STAFF REPORT

SUBJECT: FP-2022-0004
Jump Creek No. 6

LOCATION: The site is located at the northwest corner of W. McMillan Dr and N. Black Cat Rd. on Parcel S0428449525 in the SE ¼ of the SE ¼ of section 28, Township 4N, Range 1W.

B. Proposed Final Plat and Annotated Final Plat (date: 1/25/2022)

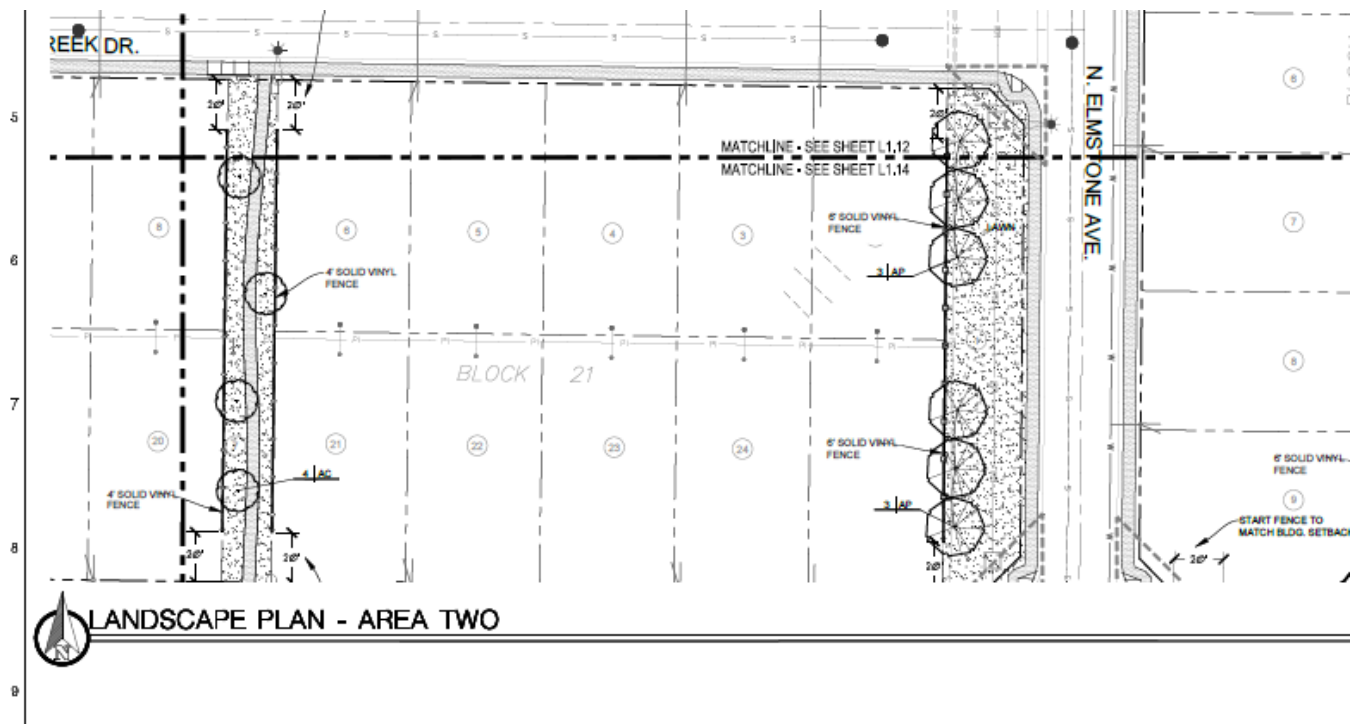
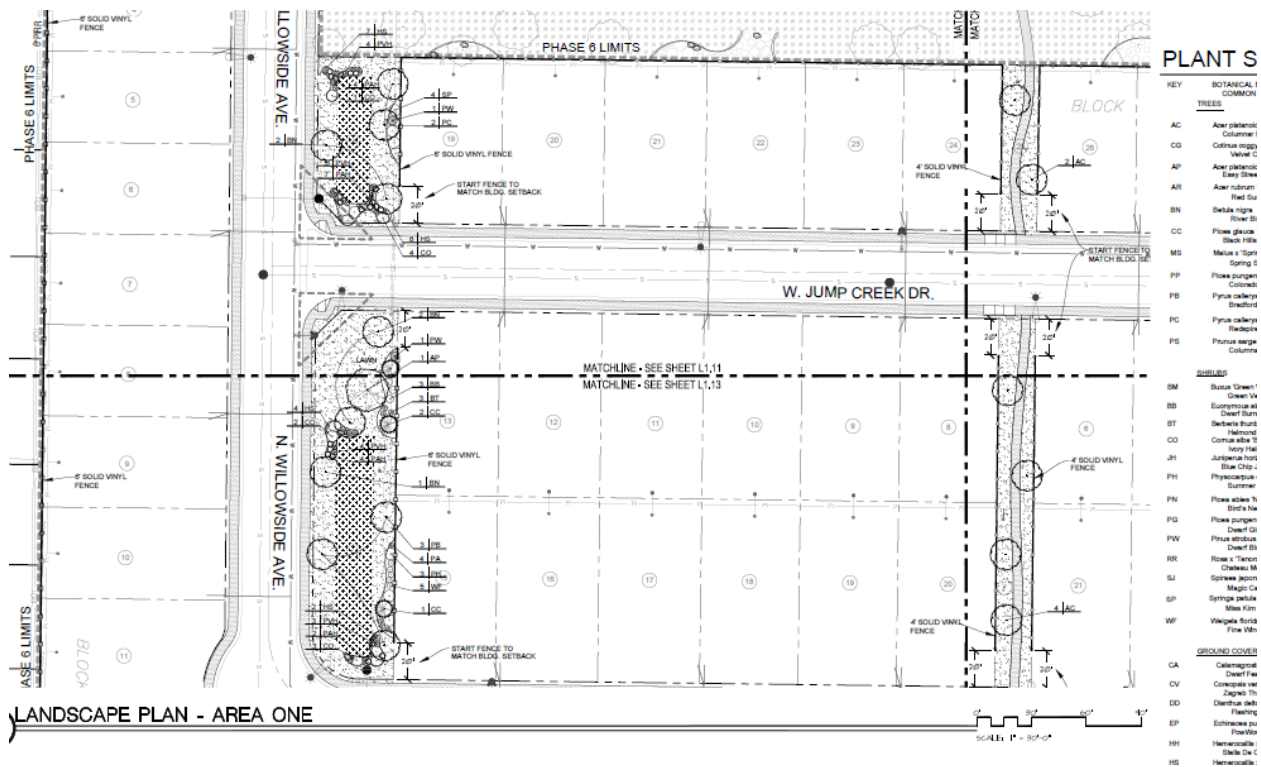
- a. Add date to the Final Plat.
 - b. Add note that Lot 7, Block 20 is unbuildable and will be platted as a separate plat.
 - c. Remove "Subdivision" from the name of the plat to read only as Jump Creek No. 6.

- d. Add a note that references the recorded development agreement (Instrument #2014-105206).
 - e. Note #8: Include recorded instrument number.
 - f. Note #9: Include recorded instrument number.

- g. Note #10: Include recorded instrument number
 - h. Note #11: Include recorded instrument number.
6. The landscape plan prepared by South Beck & Baird, dated 11/02/2020, is approved as submitted.
